# Draft NRC Response Clarification of Inspection Requirements in Technical Specifications Task Force 577 (TSTF-577)

NRC Meeting with  
Industry Steam Generator Task Force (SGTF)  
March 3, 2022

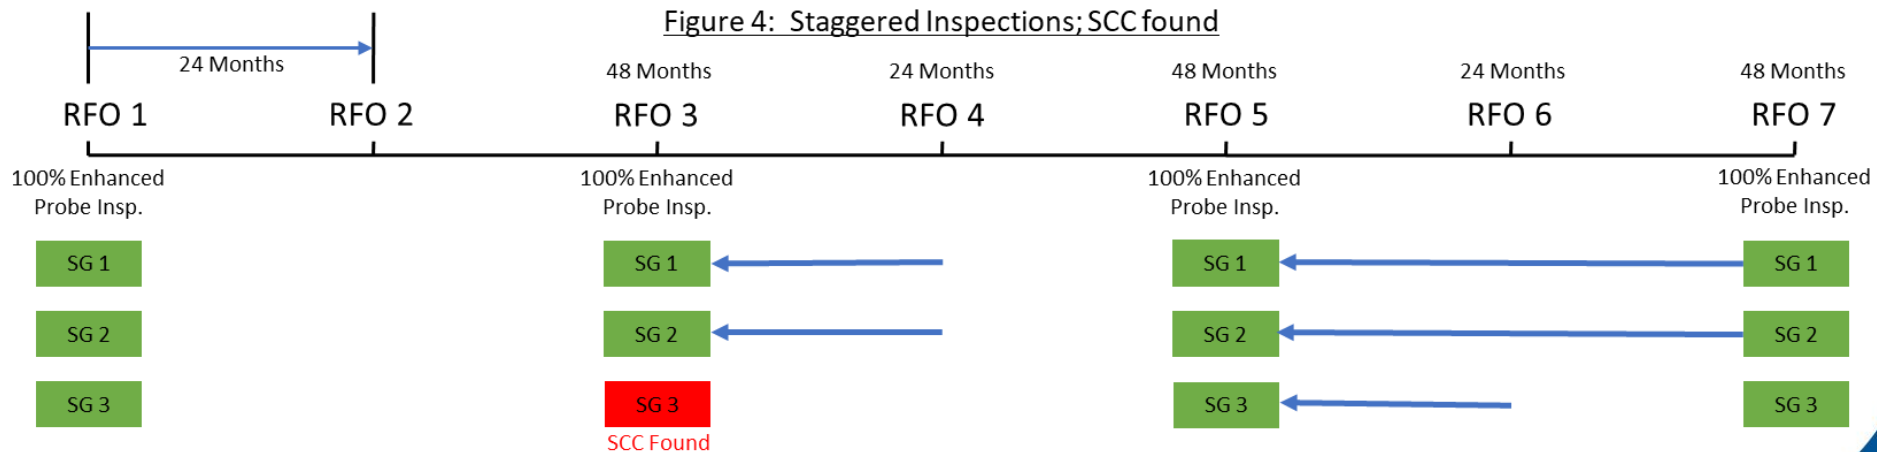
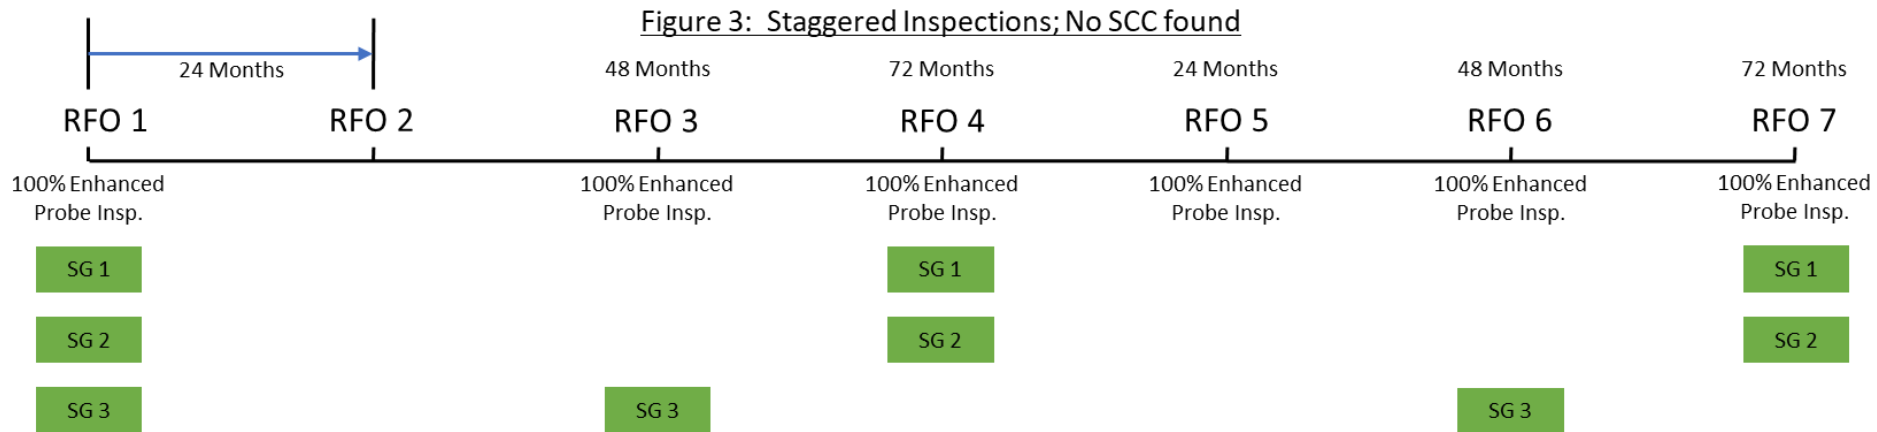
Inspection Scenario 1	Initial Crack Detection	Next Inspection and Beyond
<p>Initial 100% enhanced probe inspection was performed on all four SGs and no cracking is detected. The SGs enter a 72 EFPM inspection period. Thereafter, staggered inspections by SG (e.g., SGs 1/3 and SGs 2/4 are offset by two refueling outages (RFOs) on an 18-month fuel cycle).</p>	<p>After two cycles, a 100% enhanced probe inspection is performed in SGs 1/3. Cracking detected in SG 1. SG 3 had no cracking detected but is potentially affected by the degradation mechanism.</p> <p>SGs 2/4 may or may not have received a partial inspection from initial scope expansion but are potentially affected by the degradation mechanism.</p> <p>All SGs are now limited to a 54 EFPM maximum inspection period.</p>	<p>All SGs are now limited to a 54 EFPM maximum inspection period [basis: TS 5.5.9.d.2].</p> <p>SGs 1/3 – since a 100% enhanced probe inspection was performed and cracking was detected, inspection for the degradation mechanism is required at the second subsequent RFO [basis: TS 5.5.9.d.3].</p> <p>SGs 2/4 – inspection is required at the next RFO to meet (i) the 54 EFPM maximum inspection period [basis: TS 5.5.9.d.2], and (ii) since the SGs did not receive a 100% enhanced probe inspection after cracking was detected in SG 1 [basis: TS 5.5.9.d.3].</p>

Inspection Scenario 1a	Initial Crack Detection	Next Inspection and Beyond
<p>Initial 100% enhanced probe inspection to enter 72 EFPM. Thereafter, staggered inspections by SG sub-population (e.g., 50% of each SG per outage offset by two RFOs on an 18-month fuel cycle).</p>	<p>After two cycles, enhanced probe inspection is performed on all tubes within the subpopulation in all SGs (e.g., 50% of each SG per inspection). Cracking detected in one SG.</p> <p>All SGs are now limited to a 54 EFPM maximum inspection period.</p>	<p>All SGs are now limited to a 54 EFPM maximum inspection period [basis: TS 5.5.9.d.2].</p> <p>If less than 100% of tubes were inspected with the enhanced probe in all affected and potentially affected SGs, then inspection for the degradation mechanism is required at the next refueling outage [basis: TS 5.5.9.d.3]. In addition, any sub-population of tubes not inspected by an enhanced probe during the RFO when cracking was detected would need to be inspected at the next RFO to satisfy the 54 EFPM inspection period [basis: TS 5.5.9.d.2].</p> <p>If 100% of all tubes (scope expansion) in all SGs were inspected with the enhanced probe, inspection for the degradation mechanism for affected and potentially affected SGs is required at the second subsequent refueling outage [basis: TS 5.5.9.d.3]. Those tubes not inspected at the second subsequent refueling outage would be inspected at the third subsequent refueling outage to satisfy the 54 EFPM inspection period [basis: TS 5.5.9.d.2].</p>
